STAFF REPORT

AGENDA ITEM: **Variance – Direct Access for a Place of Worship**

CARMELITE MONASTERY DRIVEWAY FINAL GRADING UTILITY & STREET CONSTRUCTION PLAN LAKE ELMO, MINNESOTA

To:	Ken Roberts, Planning Director	Re:	Carmelite Monastery Driveway
Cc:	Marty Powers, Public Works Director Chad Isakson, Assistant City Engineer		Engineering Construction Plan Review
From:	Jack Griffin, P.E., City Engineer

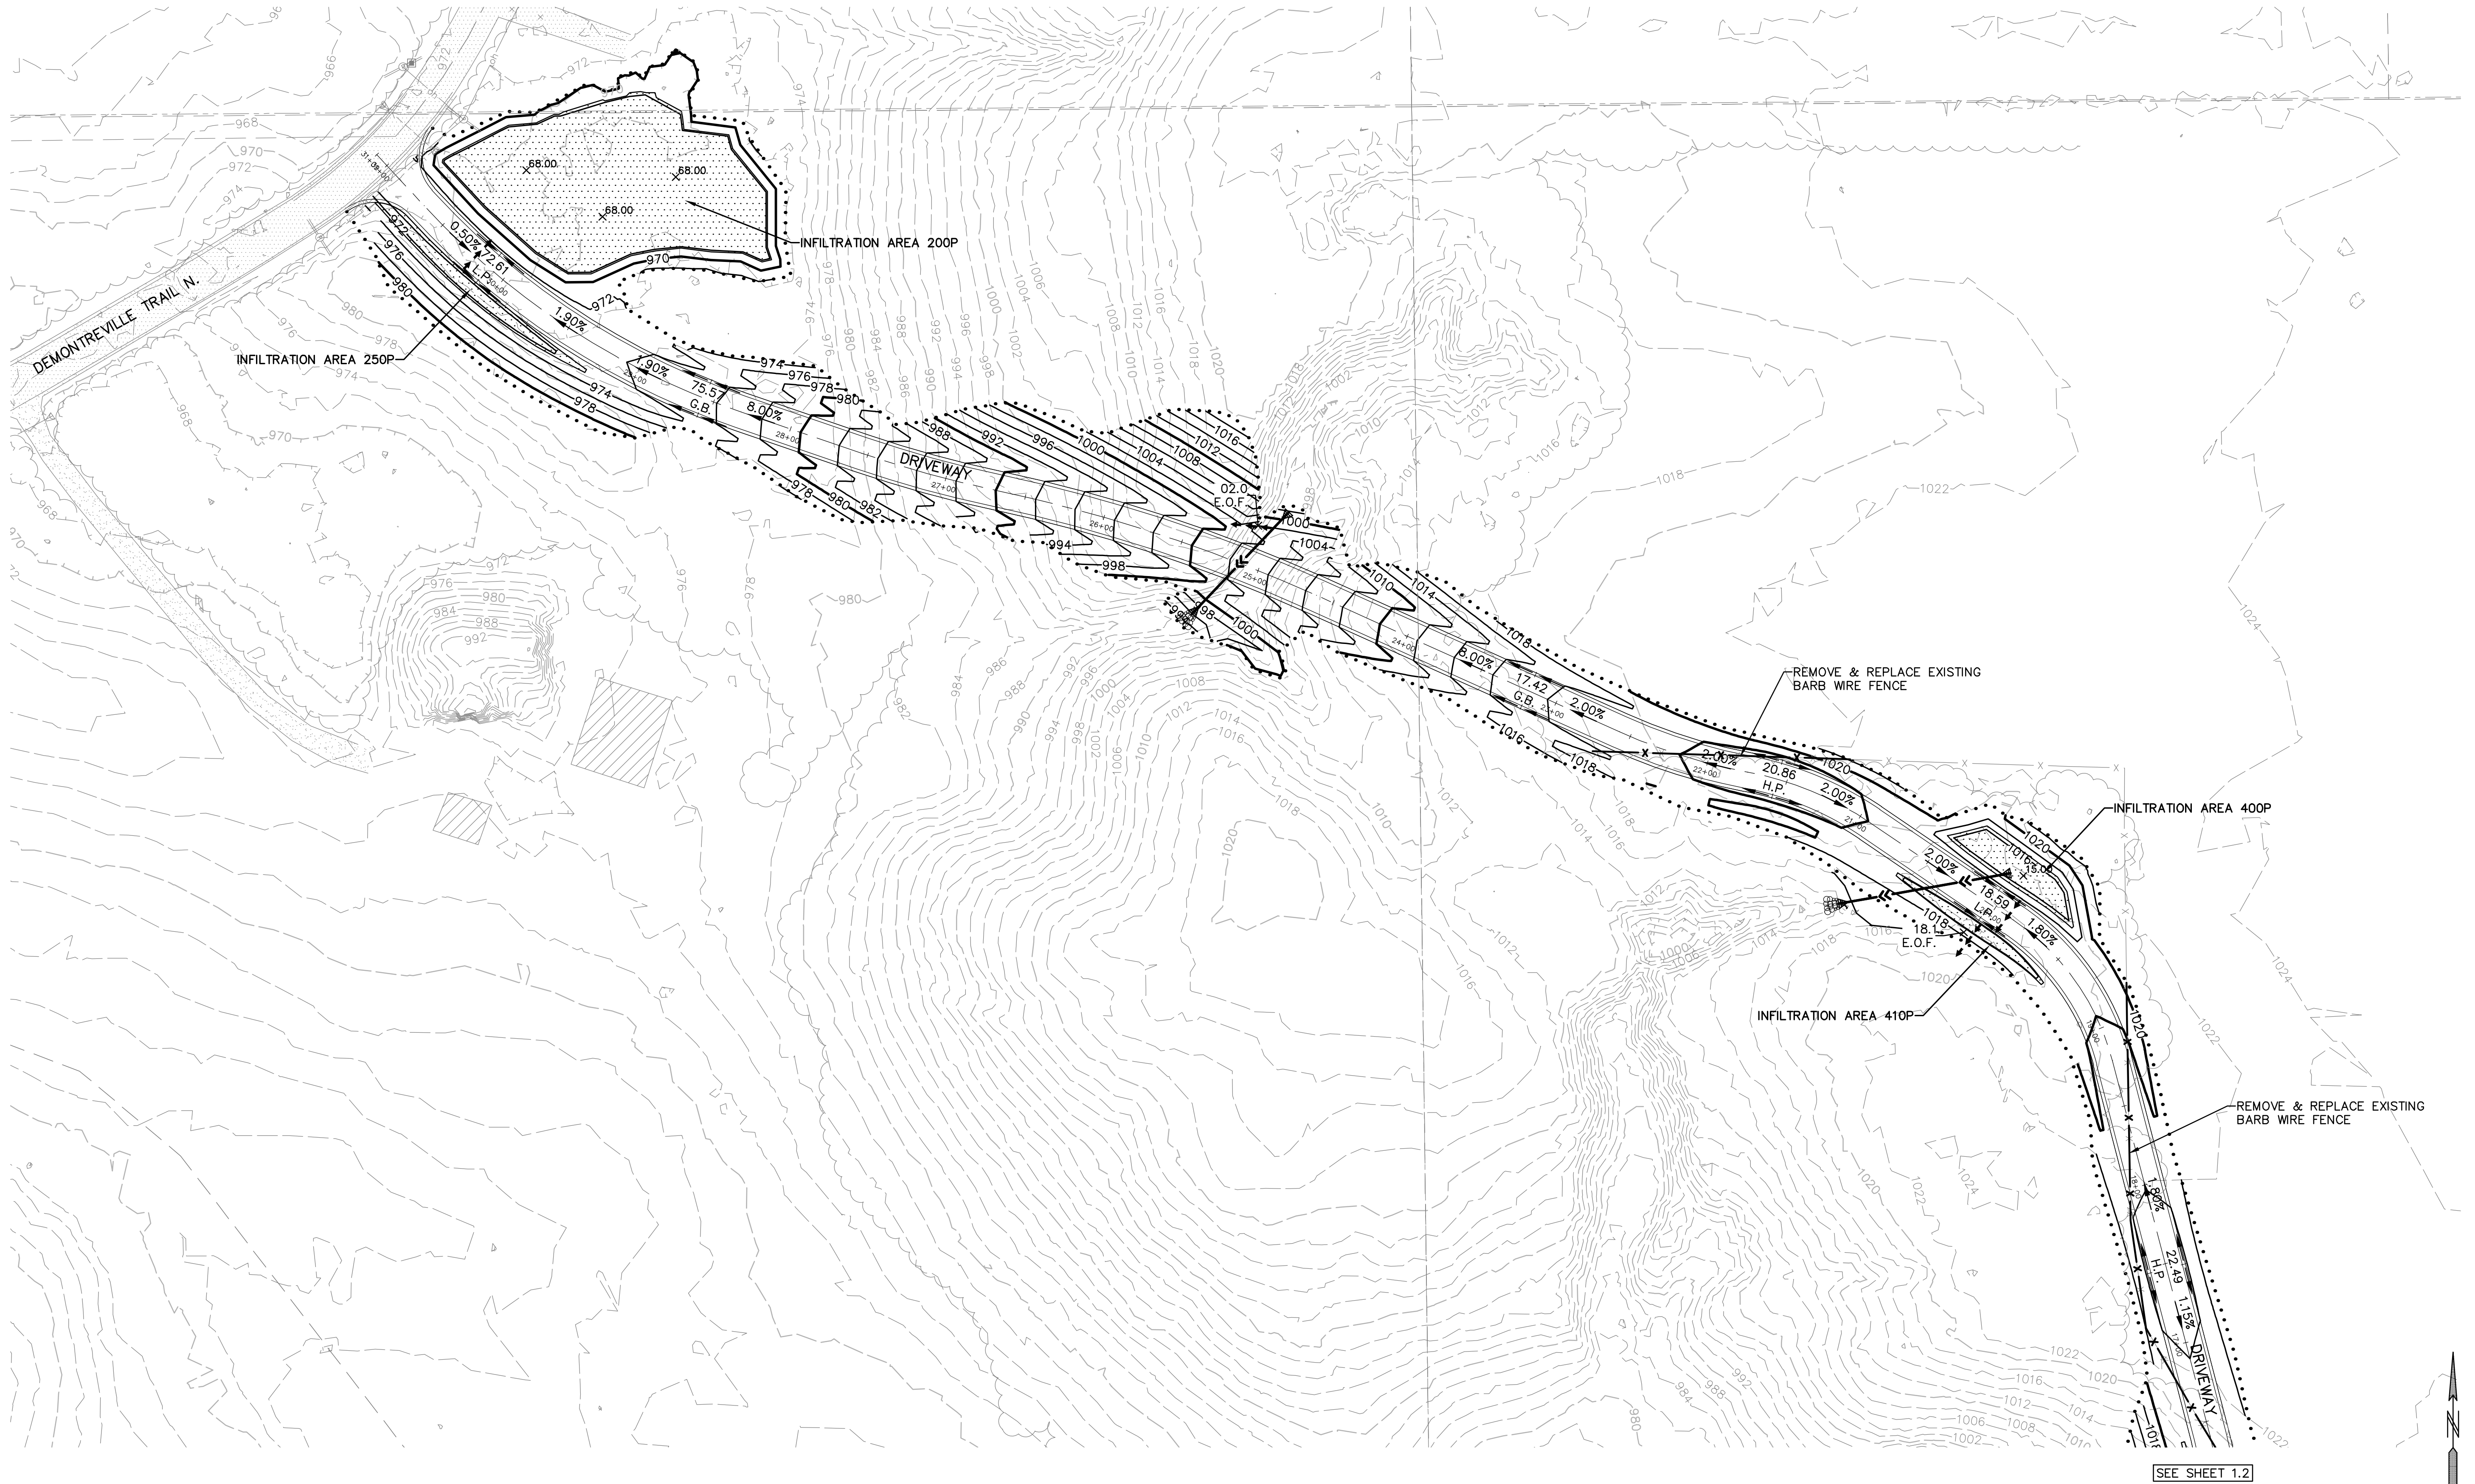
4. Revise plans to clearly show all property lines, right-of-way and easements.
5. Sheet 0.1. Add plan note to identify the standard of care guideline for the collection and depiction of existing subsurface utility data per CI/ASCE 38-02.

GRADING PLAN

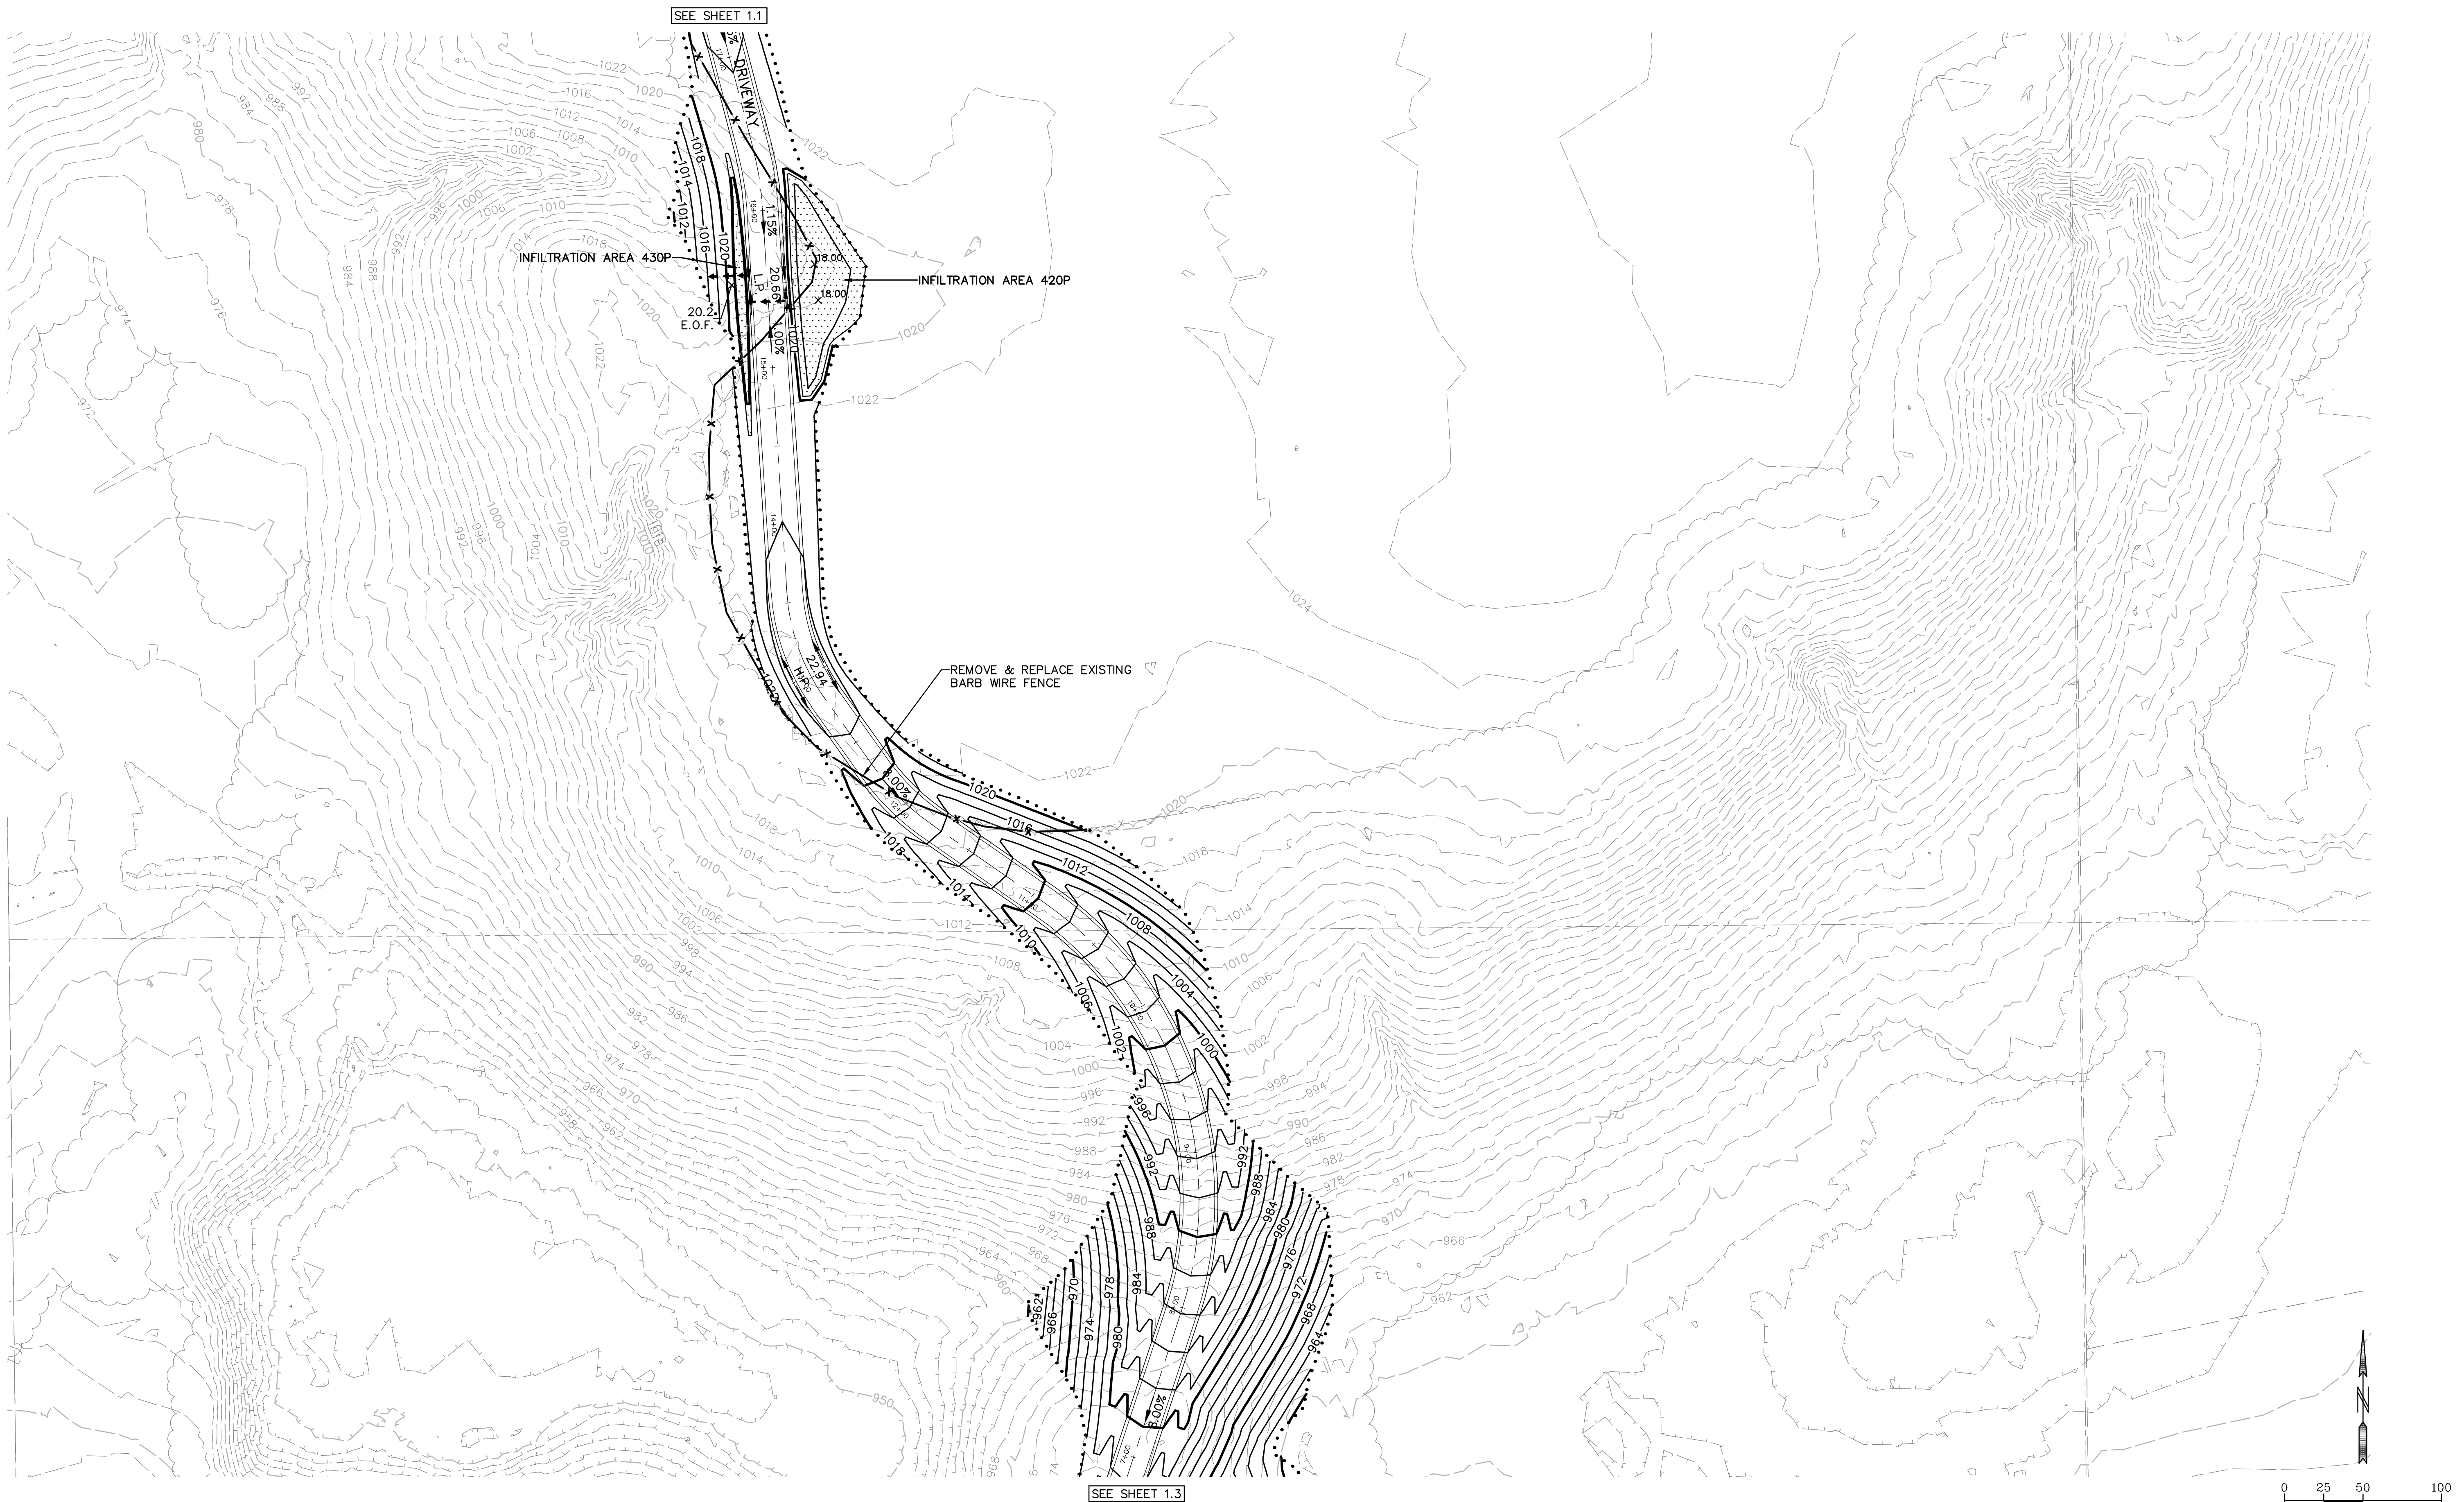
6. Sheet 1.1 – 1.3. Add culvert pipe size, material, and invert for all proposed and existing culverts.
7. Sheet 1.1 – 1.3. Add the 100-year HWL elevation and contour for all proposed infiltration basins. Add emergency overflow elevations and flow paths.

8. Sheet 1.1 – 1.3. Add proposed drainage and utility easements for each infiltration basin, incorporating the 100-year HWL elevation and contour, and maintenance access routes to all drainage structures.

9. Sheet 1.1. Revise grading plan to eliminate infiltration basin encroachments for areas 200P and 250P from the DeMontreville Trail right-of-way. Revise plans as needed to ensure the EOF flow path from 200P and 250P remain outside of the public right-of-way.
